ZON2007-00035

By same motion and vote, members recommended **APPROVAL** of a request to rezone property located at 4680 NE 23rd Avenue (Easton Blvd.) from "A-1" Agricultural District to "PUD" Planned Unit Development; and **APPROVAL** of "The Woods of Copper Creek" PUD Conceptual Plan for approximately 71 acres for 60' wide lot single-family residential development, approximately 22 acres of 70' wide lot single-family development, and approximately 18 acres for future multiple-family residential development to be defined with a future amendment, subject to the addition of the following: (ZON2007-00035)

THE WOODS OF COPPER CREEK PUD CONCEPTUAL PLAN

HDR Land Development LLC - 4680 NE 23rd Avenue

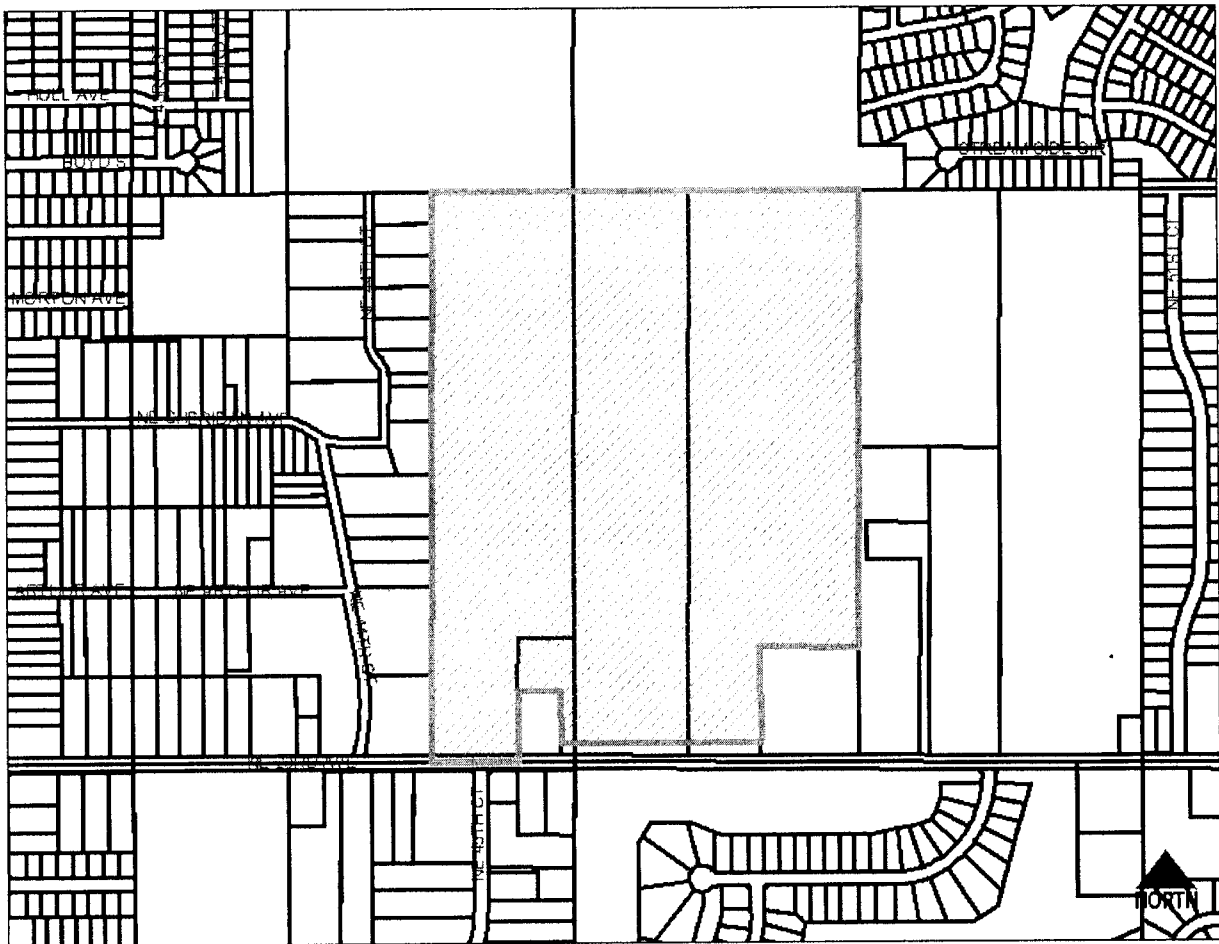
The PUD Conceptual Plan indicates that low-level shrubs and/or flower landscaping elements will be provided within all landscape islands within cul-de-sacs. These landscape areas would be planted by the developer and owned and maintained by a homeowners association. Staff recommends that this be revised to also include landscape islands within traffic circles.

The Traffic and Transportation Division has requested provision of a traffic circle in the north 4-way intersection of the eastern collector street. They have also indicated that the PUD Conceptual Plan must allocate half of the 80' ROW needed for NE 23rd Avenue and provide a 37' width pavement on the streets at NE 23rd to allow a 150' left-turn lane and taper back to 31' width.

- 10. **Architectural Guidelines:** The revised PUD Conceptual Plan submitted following the July 19, 2007 Planning Commission satisfies all of the conditions previously recommended in the Staff Report except for the requirement that dwellings have either architectural or cedar shingles.

The PUD Concept Plan proposes that roofing materials shall be asphalt-type shingles and that architectural shingles or cedar shakes are optional. The developer believes that as a trade-off for not requiring architectural shingles, they are 1) providing 19.4 acres of preservation easements, 2) exploring alternate setbacks from lot to lot where possible, and 3) exploring use of low impact design methods for stormwater management during the design and grading phases.

1. The roof on any home constructed shall be of architectural-type shingles or cedar shakes.
2. Provision of a traffic circle in the north 4-way intersection of the eastern collector street, with low-level shrubs and/or flower landscaping elements within the traffic circle that would be planted by the developer and owned and maintained by a homeowners association.
3. PUD Conceptual Plan must allocate half of the 80' ROW needed for NE 23rd Avenue.
4. PUD Conceptual Plan must provide a 37' width pavement on the streets at NE 23rd to allow a 150' left-turn lane and taper back to 31' width.
